Proposed modification of the Fraser Drive Residential Subdivision (MP 06_0243 Mod 5) at Lot 2 DP 1000385 & Lot 212 DP 1231622 & Lot 9 DP 1039569; Fraser Drive TWEED HEADS SOUTH

I refer to Department's invitation for Council to provide comment on the proposed modifications (Mod 5) of the Fraser Drive Subdivision. Upon review of the modification application, please find below Council's comments:

Figure 2: Council mapping of existing stormwater pipe

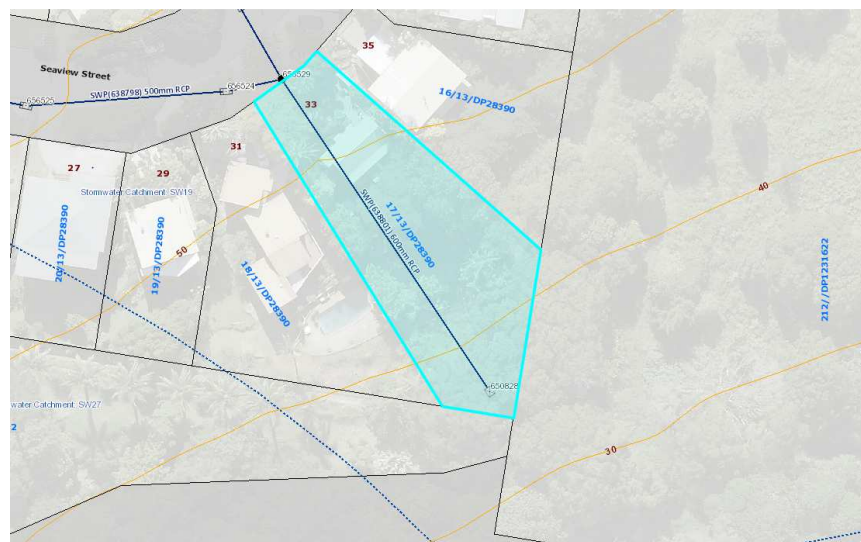
In addition to the above, Tweed Shire Council mapping indicates a 600mm diameter stormwater pipe through Lot 17 sec 13 DP 28390 (No. 33 Seaview Street) as shown in Figure 2 below.

The above stormwater to be taken into consideration for design.

Figure 3: Council mapping of existing stormwater pipe

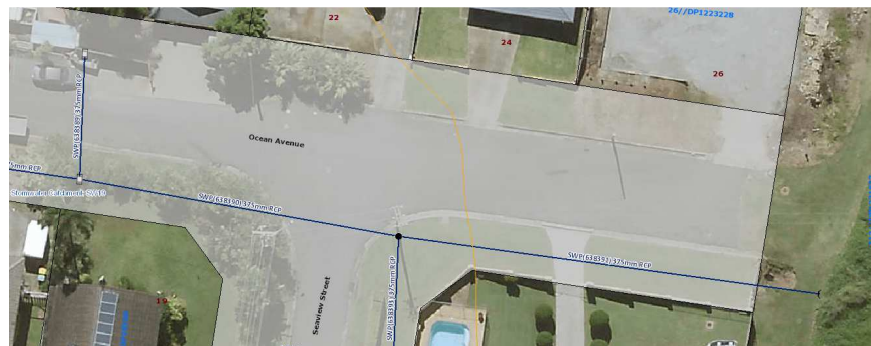
Tweed Shire Councils mapping indicates that there is an existing stormwater pipe in Ocean Avenue as shown in Figure 3 below.

The proposed stormwater design does not appear to take into consideration this existing stormwater connection.

Figure 4: Council mapping of existing stormwater pipe

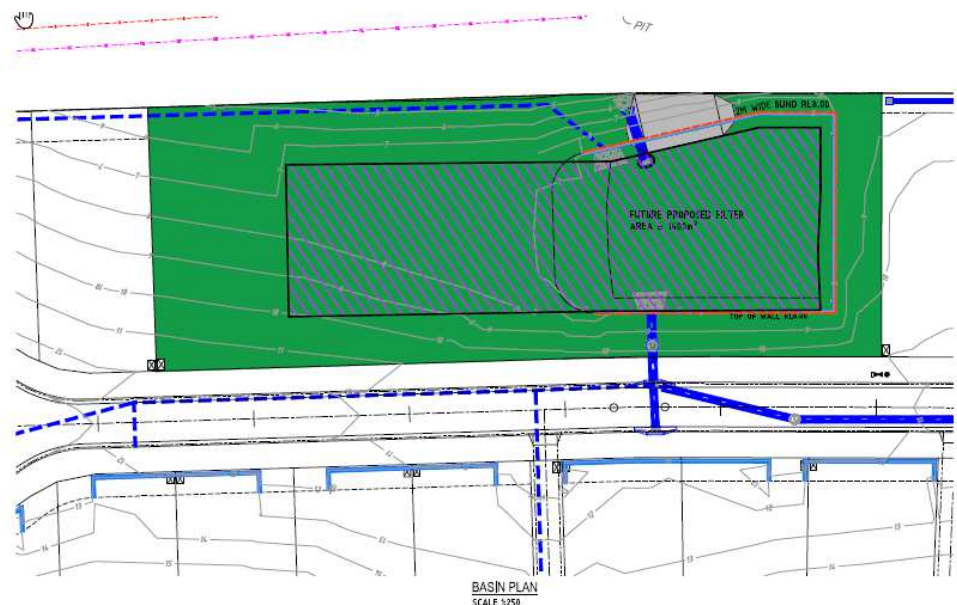
To comply with contemporary stormwater quality policy the development will almost certainly opt to incorporate a bio-retention basin in to the stormwater management lot adjacent Fraser Drive. This has been foreshadowed in recent design documentation submitted as part of a section 68 (Local Government Act 1993) application for the Stage 12 construction certificate. Early concept design suggests around 1400m² of bio-retention surface area will be required (see Figure 4 below). On top of this, batters to fit the basin onto the slope will increase the area required to accommodate the infrastructure.

Complying with current best practice stormwater quality management and Development Design Specification D7 (as per Conditions B18 and B20) will require significant land area in the stormwater/open space lot adjacent Fraser Drive. This is not currently considered in the proposed lot layout.

The applicant should provide a compliant Stormwater Management Plan that includes a clear definition of the infrastructure required to comply with Development Design Specification D7 – Stormwater Quality. The

Figure 8: Lot 185 Topography & Stormwater Basin

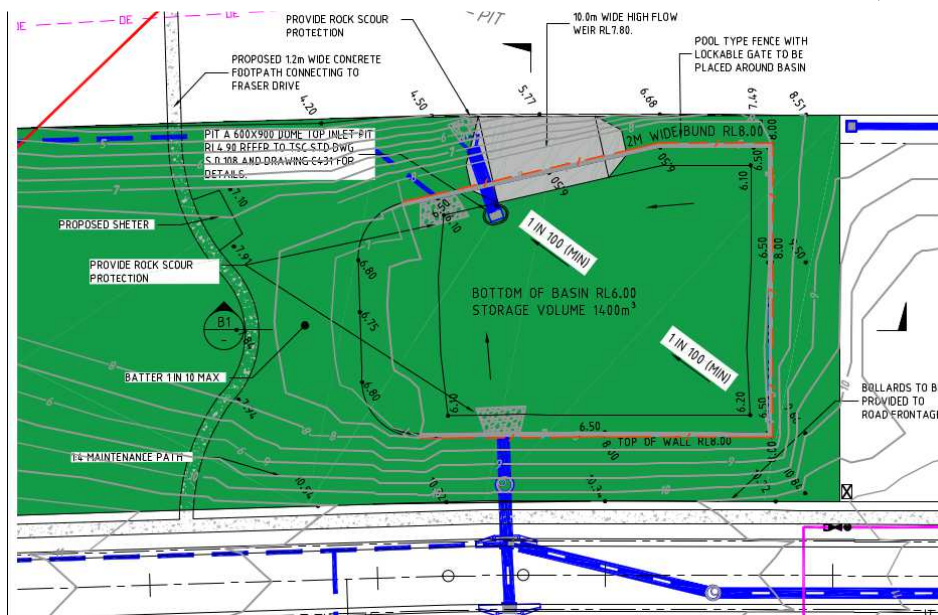
Details within the SWMP (refer to Figure 8 below) highlight the topography and quality of the open space provision.

In addition, it appears the basin will retain water ongoing to a depth of 0.5m with 1.5m high walls on three sides and 10m wide concrete weir. The water retention generally requires fencing around all sides for safety (greater than 300mm in depth). Fencing is only provided along the top of the 1.5m high walls with fencing excluded on the northern side which directly faces the 'park' embellishments, reflecting poor open space design. It is considered that the infrastructure does not allow for the northern half of Lot 185 to be included in the open space contribution. Further, topography of the proposed open space is too steep to be considered usable. The path through the 'park' does not meet the required maximum 1:14 access gradient. 1:1 to 1:4 batter is proposed within the open space area for most of the northern area. This renders much of this site not usable open space.

Regarding 'Landform', a minimum of 80% of the area is to be less than 8% grade. Figure 7 above states 1870m² of usable space is provided on Lot 185, however given the topography as outlined in Figure 8, it is considered that only approximately 350m² meets this criteria.

Figure 9: Lot 185 Open Space Embellishment

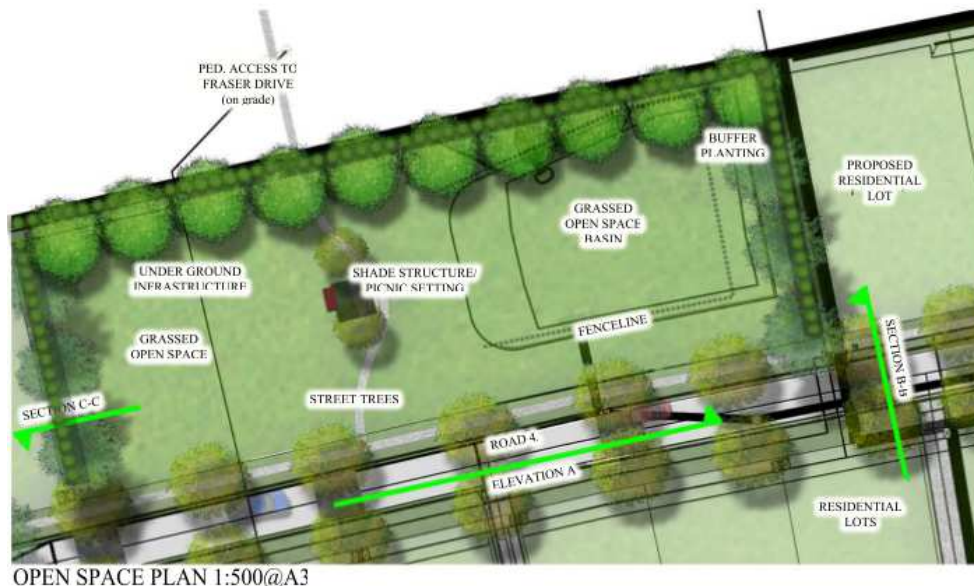
The Statement of Landscape Intent (refer to Figure 9 below) shows the proposed embellishments.

The level of proposed embellishment features plantings, a path, shade structure and picnic setting. In addition to less than 350m² being usable, in accordance with 'Amenities' in Table A5-8.2.1, the site is required to be *"...Appropriately embellished with play equipment, soft fall surfaces under play equipment, kick about area, paving for ball games, seating with shade, landscaping, drinking fountains, general shade and lighting. Play areas appropriately fenced from balance of park area to delineate changed use"*.
